Specialized Seismic Option Report - Action Item List from June 2016 NRC Audit - Updated

The U.S. Nuclear Regulatory Commission (NRC) staff conducted an audit related to the review of HSP-GW-GLR-001, "The Specialized Seismic Option Report" (Option Report). The primary audit took place June 7–9, 2016 at the Westinghouse facility in Rockville Maryland. The staff audited documents that support the Option Report evaluations and conclusions. Action items were collected during the audit and subsequent telephone calls and meetings. Attachment A provides the complete action item list and the status of each item. There are a total of 61 action items. The status of the action items is broken down into four categories, as follows

Specialized Seismic Option Report (OR) Text Revisions<sup>1,2</sup>  
(Westinghouse Non-Proprietary Class 3)

Table 3H.5-9 (Sheet 1 of 34)

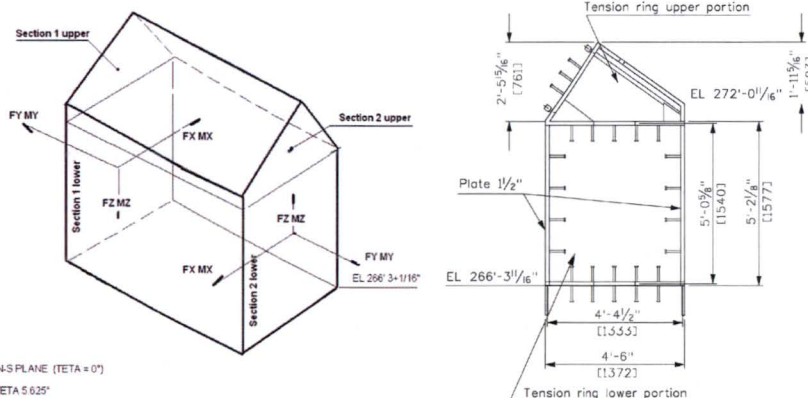
23	Provide the basis for the composite uncertainty (beta values).	Closed during the audit.
24	Provide the Passive Containment Cooling System (PCS) tank interior wall in markups of Table 3H.5-9. SMA - clarification for the PCS Tank High Confidence Low Probability of Failure (HCLPF). Clarify where related markups for the Topical Report came from. Add table for PCS tank wall.	Closed – to be confirmed by NRC: Clarification is provided in the revised OR Appendix A (DCD Mark-up) Revisions provided in Attachment C to this letter.
25	Add an additional example to "conservatism in the structural qualification approach" (page 5-4). [ ] <sup>a,c</sup> Add more details to the report.	Closed – issued as RAI-SSO-012.

AI #24
